Subject: The Woods Road Solid Waste Management Facility

CH2M HILL has prepared the attached supplemental information, as requested by the County of Loudoun (the County), to support the Woods Road Solid Waste Management Facility Part A Permit Application (Application) submitted to the Department of Environmental Quality (DEQ) on February 19, 1993. The purpose of this supplemental information is to address the March 14, 1993 DEQ permit review comments. Responses to each of the ten DEQ comments are addressed below as follows:

Subject: The Woods Road Solid Waste Management Facility Part A Permit Application

The purpose of this letter is to clarify our response to the Waste Division of the Department of Environmental Quality comments, dated July 9, 1993, regarding the Woods Road Solid Waste Management Facility Part A permit application supplemental information submitted on May 27, 1993. As indicated in your letter, dated July 9, 1993, the Woods Road site is located in a seismic impact zone and therefore, the following demonstrations are required per Section 5.1.A.6 of the *Virginia Solid Waste Management Regulations* (VR 672-20-10) and include:

Modified from Algermissen et al. 1990

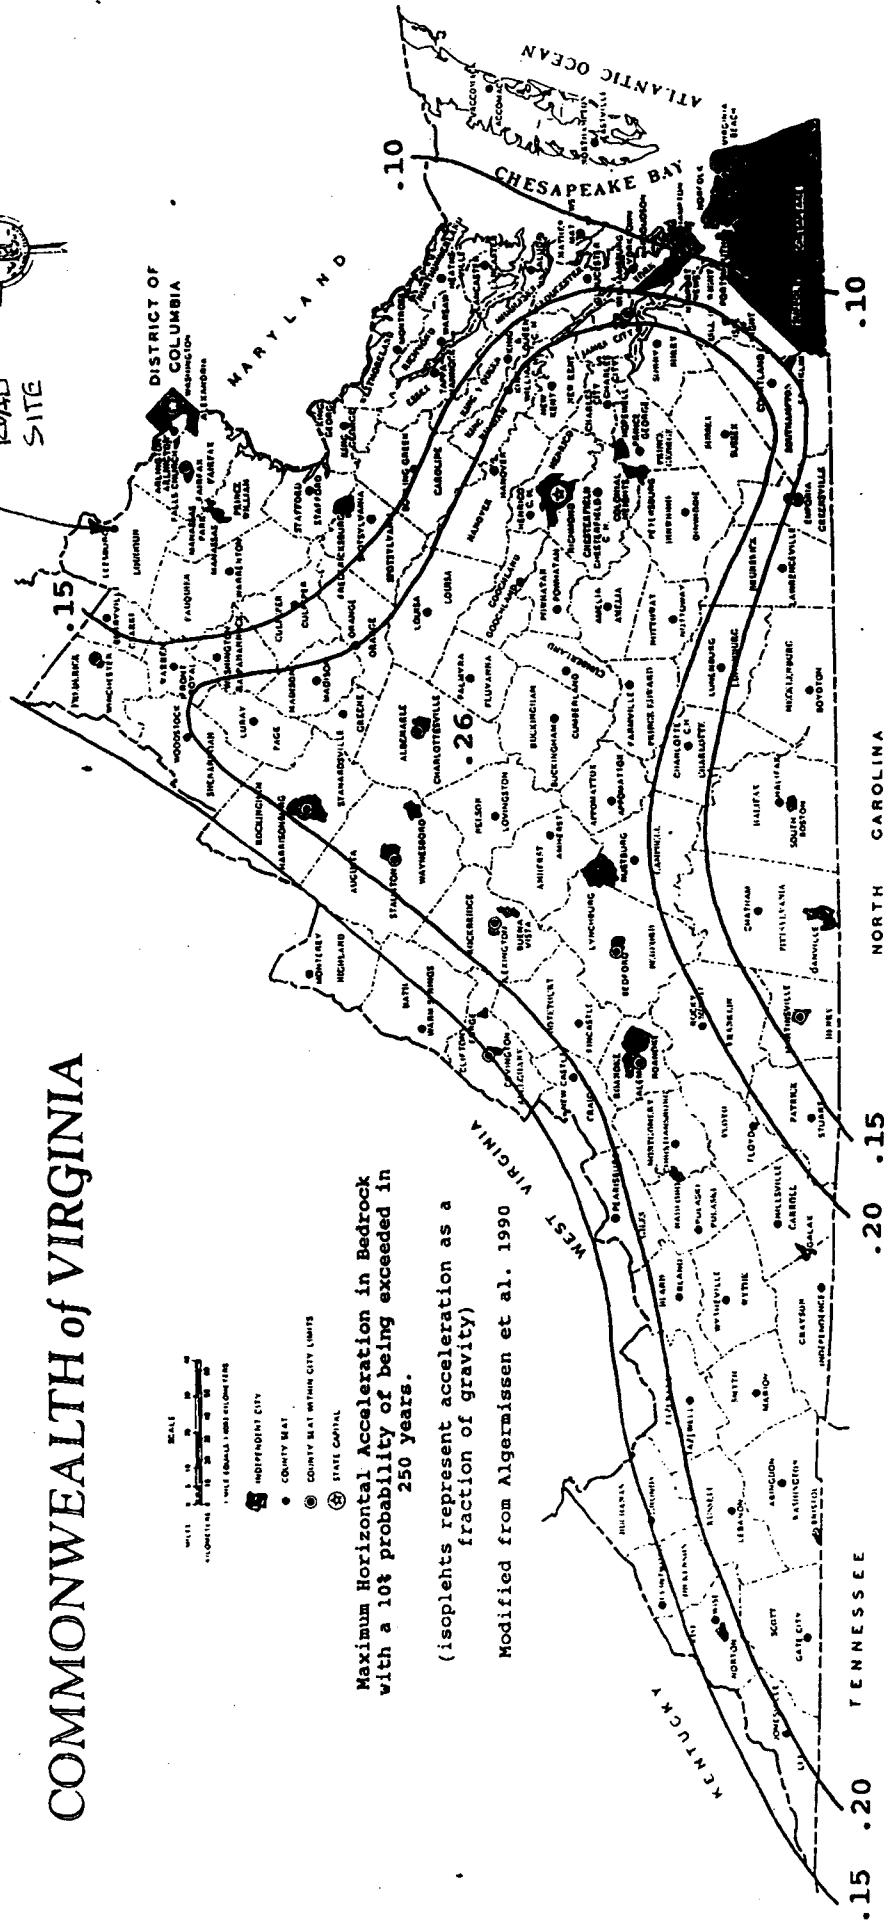
As a clarification to Comment response No. 3 of our letter dated May 27, 1993, the maximum expected horizontal acceleration in bedrock with a 10 percent chance of occurring in a 250 year return period is 0.1g. The depth to top of rock from the ground surface at the Woods Road site varies from 51 to 103 feet with an average depth of 103 feet. The soils overlying bedrock generally consist of medium dense well graded silty sand to firm sandy silt. The maximum anticipated amplification factor for these site conditions is 1.5. The maximum expected

THE PROPOSED WOODS ROAD SITE IS LOCATED IN A SIZ WITH A MAXIMUM HORIZONTAL ACCELERATION IN BEDROCK OF 0.1g. (SEE ATTACHED FIGURE MODIFIED FROM ALGERMISSEN ET AL 1990).

Figure 40. Range of values of  $r_d$  for different soil profiles.

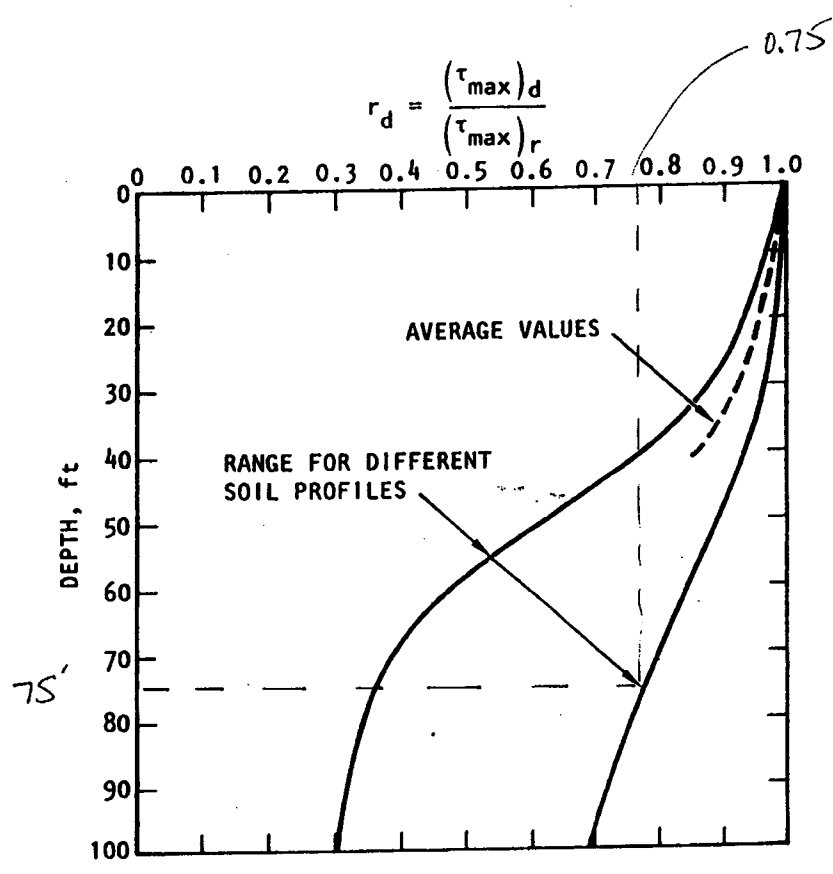
$r_d$  = STRESS REDUCTION FACTOR = 0.75 <sup>(SEE FIG. ATTACHED)</sup>

Figure 47. Chart for values of  $C_N$ .

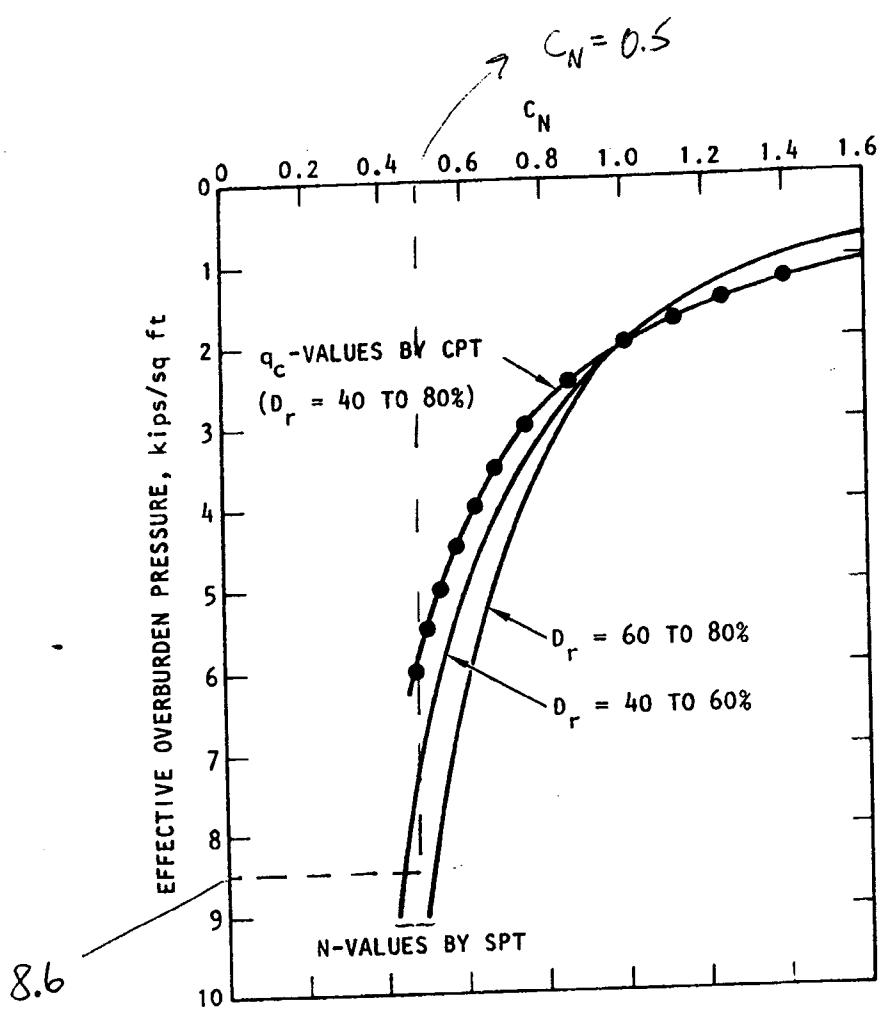
$$C_N = 0.5 \quad (\text{SEE ATTACHED FIGURE 47, SEED ET AL 1982})$$

Figure 57. Chart for evaluation of liquefaction potential for sands for different magnitude earthquakes.

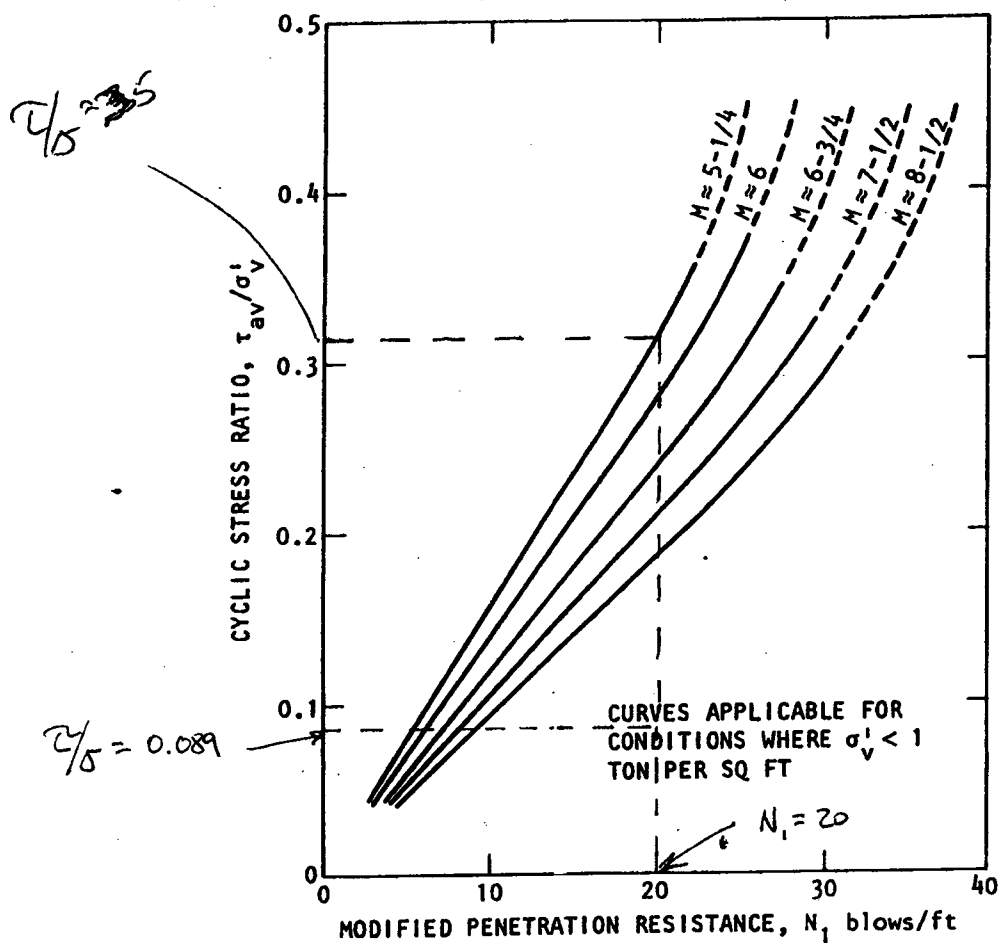
ENTER FIGURE 57 (SEED ET AL 1982)

ASSUMING MAGNITUDE 5 EARTHQUAKE IS  
THE THRESHOLD FOR LIQUEFACTION THEN  
FROM FIGURE 57 WITH  $N_1 = 20$  AND  $M = 5$

$$FS = \frac{0.35}{0.09} = 3.9$$
